Informal document No. GRE-65-07
(65th GRE, 28-31 March 2011,
agenda item 5(j))

Collective amendments - Regulation Nos. 53 and 113

Proposal for Amendment to Regulation No. 113 (Headlamps emitting a symmetrical beam) for introducing additional light source and additional light unit

Annex 8

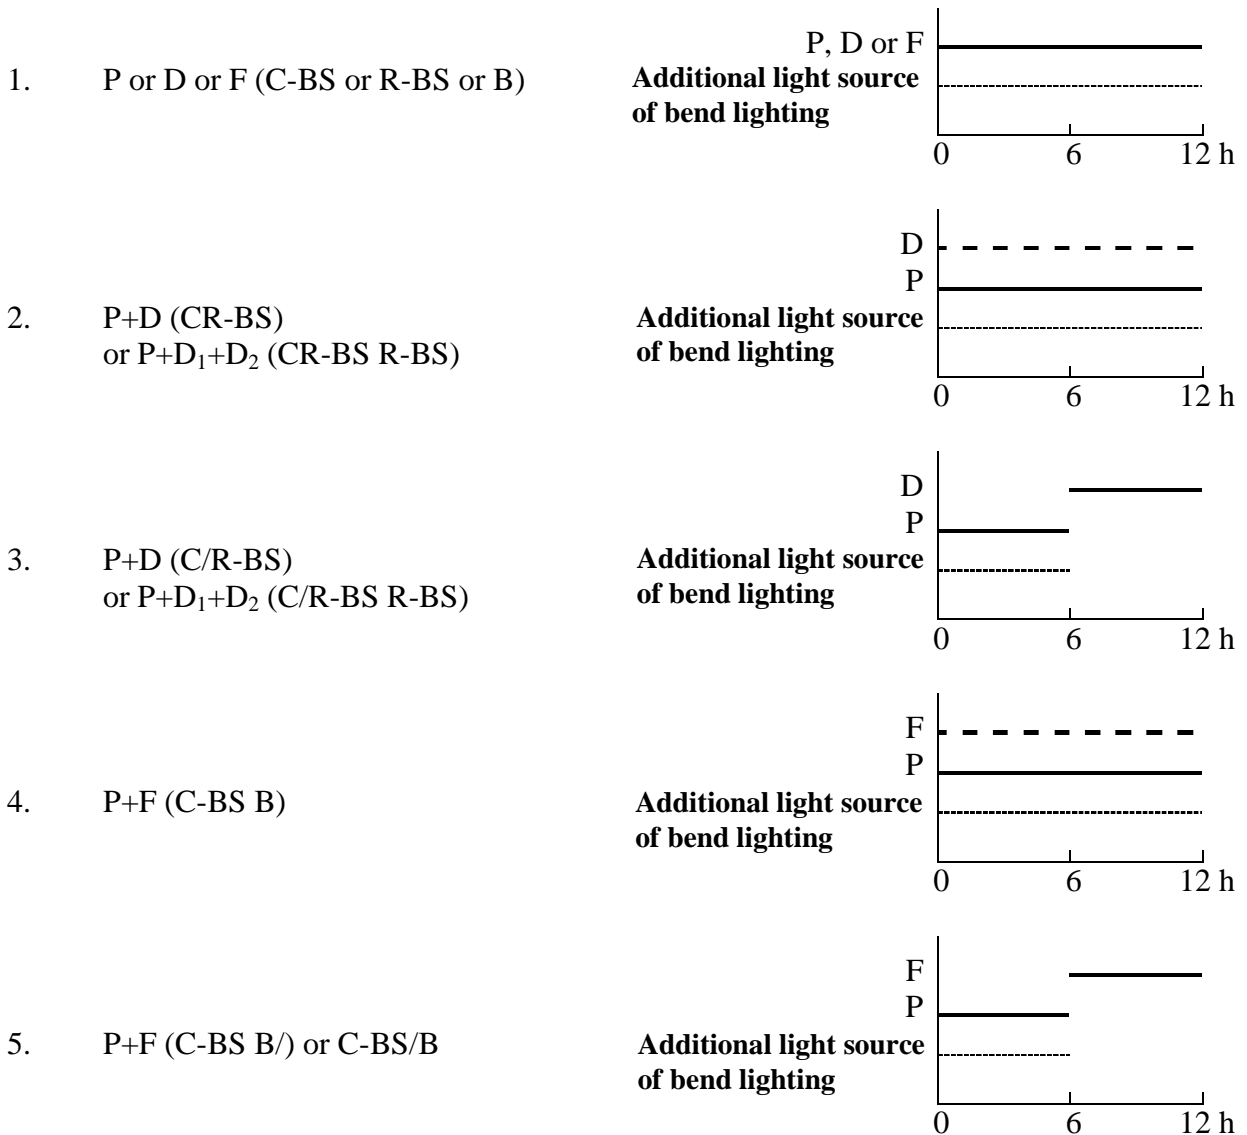
Annex 8., amend to read:

- Abbreviations: P: passing beam lamp
 D: driving beam lamp (D₁ + D₂ means two driving beams)
 F: front fog lamp
 - - - - - : means a cycle of 15 minutes off and 5 minutes lit.
 : means a cycle of 9 minutes off and 1 minutes lit.

9. P+D+F (C/R-BS B)
or P+D₁+D₂+F (C/R-BS R-BS B)

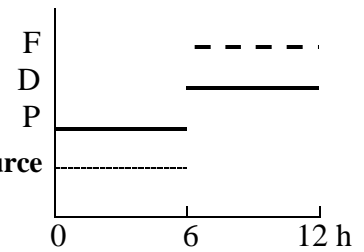
**Additional light source
of bend lighting**

10. P+D+F (CR-BS B/)
or P+D₁+D₂+F (CR-BS R-BS B/)

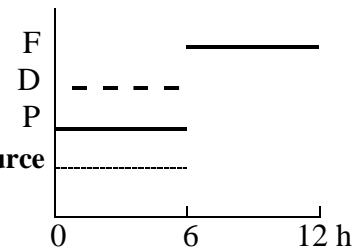
**Additional light source
of bend lighting**

11. P+D+F (C/R-BS B/)
or P+D₁+D₂+F (C/R-BS R-BS/B)

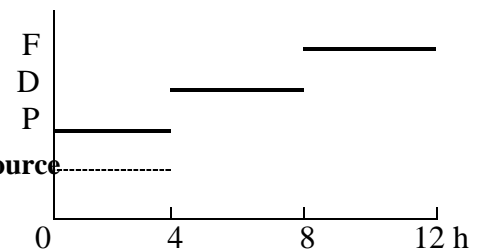
**Additional light source
of bend lighting**
